AMENDMENT OF SOLICITATION/MODIFICATION OF CONTRACT

The purpose of this amendment to IFB NNM13ZPS002E, The purpose of this amendment to IFB NNM13ZPS002E, Construct Replacement Building 4260, is to provide answers to questions asked by several of the potential bidders. These questions and answers are being provided to assist all contractors in preparing their bid.

IFB NNM13ZPS002E, Amendment 1

Revisions of Drawings 15 and 16

REF. NO. A15 15 OF 29

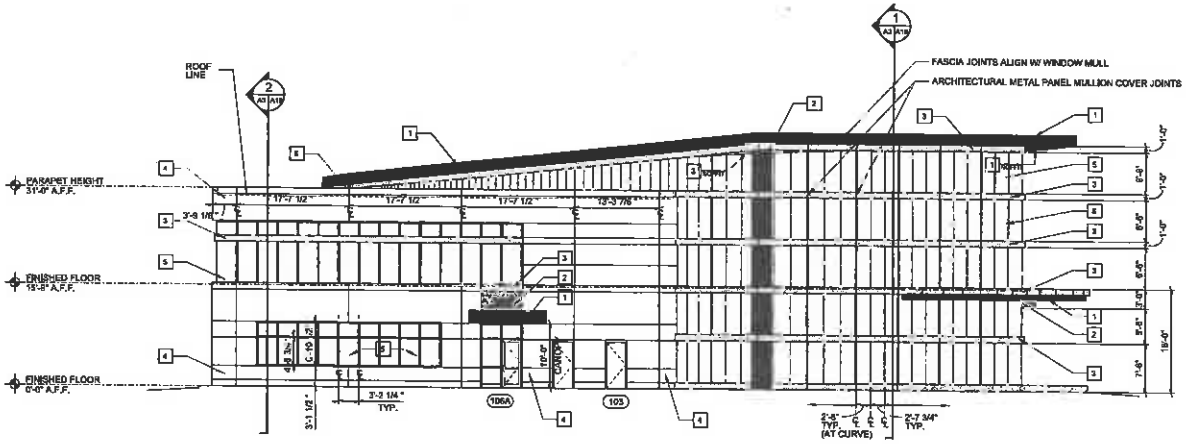
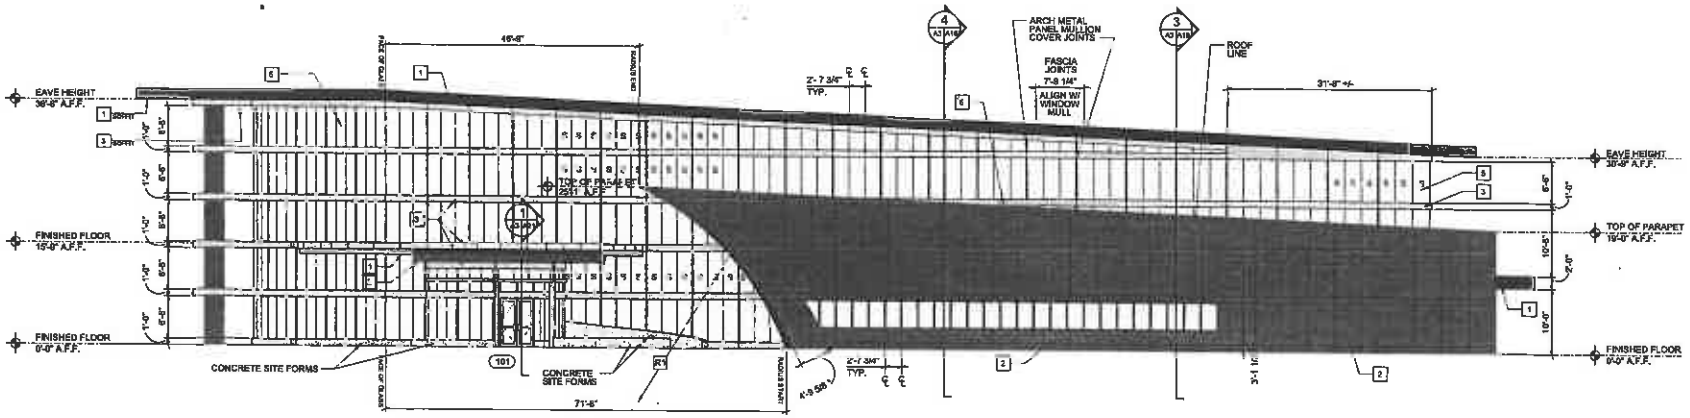
Question 1: Can you provide a different A15 and A16? The legend shows differing colors/patterns, but they are not visible.

Answer: Drawings A15 and A16 were printed incorrectly in the package of drawings. The drawings had various shades of gray in both the legend and on the building elevations that were not distinguishable in the set going out for bids. Revisions to drawings A15 and A16
